**Statement of Response to An Bord Pleanála in respect of a  
Strategic Housing Development at the Glebe House and Coruba  
House site, St Agnes Road, Crumlin, Dublin 12.**

**On behalf of Seabren Developments Ltd and Circle VHA CLG**

**June 2022**

Figure 2.1 – Existing Bus Stops North of the Site

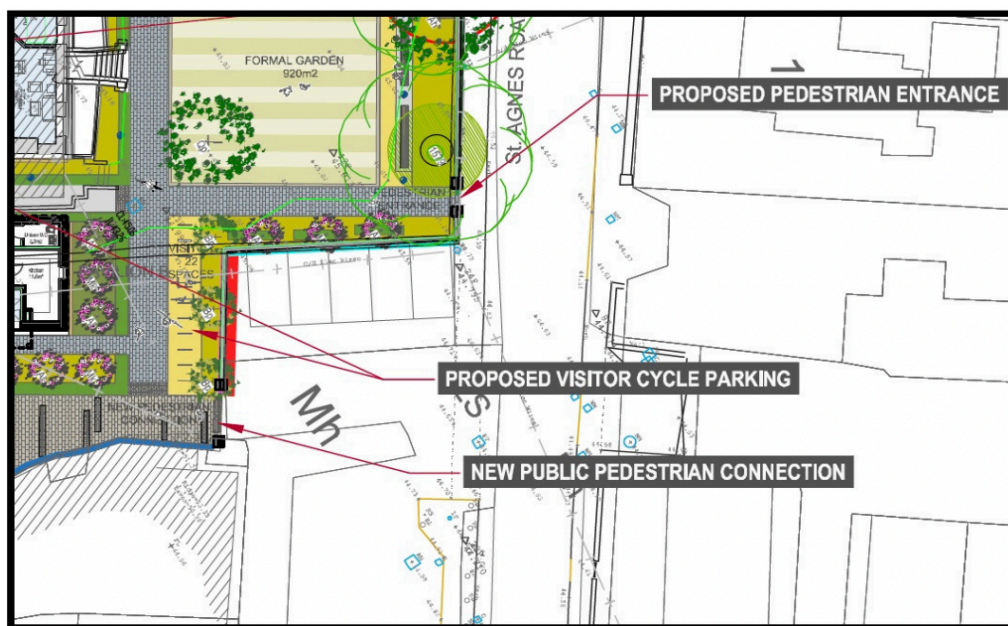
- NRB examined the latest available census date (2016) to examine car ownership in the Crumlin area. The data confirms that 20% of the population in the area are commuting as car drivers. It also confirms that nearly 30% of the existing households in the catchment currently have no car. This data further supports the case for the reduced parking provision at the site.
- In relation to the statement from DCC that there are 'limited alternative transport options', NRB have included a Bus Capacity Assessment Report appended to their

The site is served by frequent existing Dublin Bus Services, with Go-Ahead Service #18 & Dublin Bus Service #150 passing the site (the nearest northbound bus stop is located 105m from the existing site access and the nearest southbound bus stop is located 65m from the existing site access).

There are additional services to Crumlin Village such as #27 nearby, with a combined peak period bus frequency of less than 10-minute intervals, representing a high frequency service. In terms of 'Modal Split Targets' the report notes that any such targets are normally and ordinarily set within a working Mobility Management Plan when the development becomes operational and occupied.

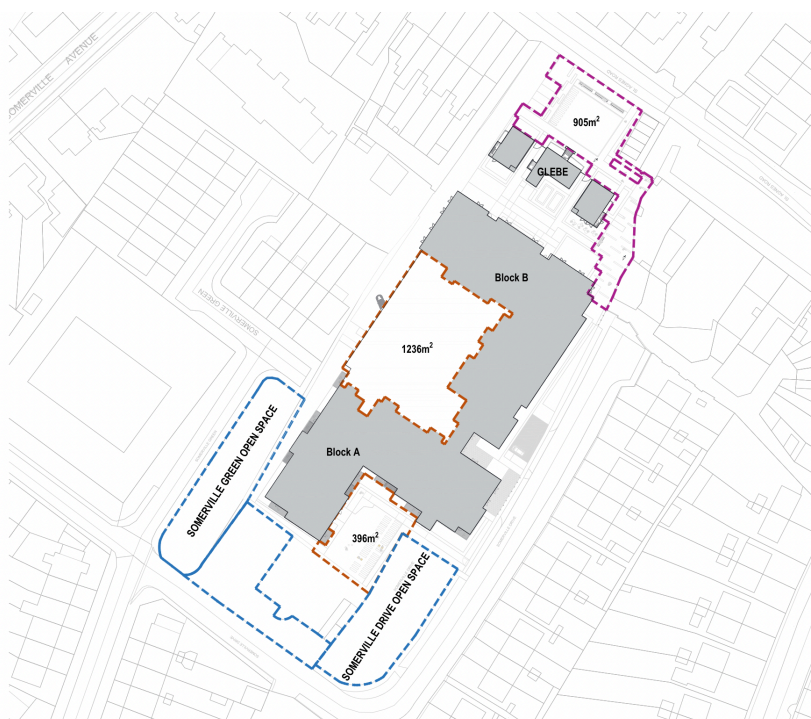
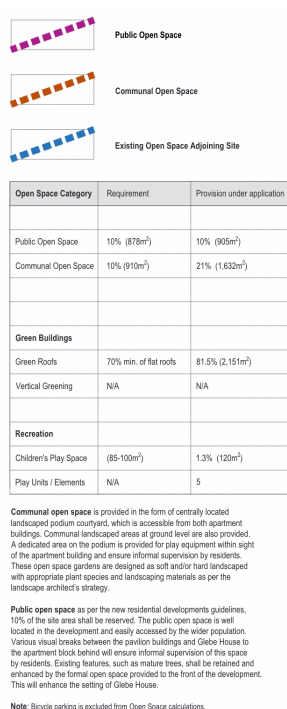
*Details of the investigations completed to confirm the feasibility of the proposed route and connection to the public surface water sewer. Surface water sewer design details including sections shall be submitted.*

*Detail of proposed surface water infrastructure that is proposed for 'taking in charge', if any, shall be indicated on a layout.*

CORA Response: Existing drainage records have been used to identify the local sewer infrastructure the layout is shown on CORA drawing C.001(P6). The surface water route has been designed to ensure no conflict with existing services. Section details are shown on the previously submitted CORA drawings C.020-C.024. Detail of proposed phasing of surface water drainage works. CORA Response: A section has been added to the CORA water services report (Section 5) outlining the proposed phasing of the surface water network. The internal drainage will be constructed as Block A and Block B progress from foundations to superstructure. The Attenuation tanks will be installed following completion of the superstructure and prior to the construction of the podium level. Once all superstructures are complete the soakaway to Glebe House and the remaining subsurface pipe network will be installed. It should be noted this phasing sequence is preliminary and will be finalized by the contractor prior to the works.

CORA response: There is no proposed surface water infrastructure to be taken in charge within the 'site boundary'. The proposed section of surface water pipe outside of the boundary to the Southwest of the site is to be taken in charge. All surface water infrastructure will be constructed in line with Dublin City Council Drainage Standards.
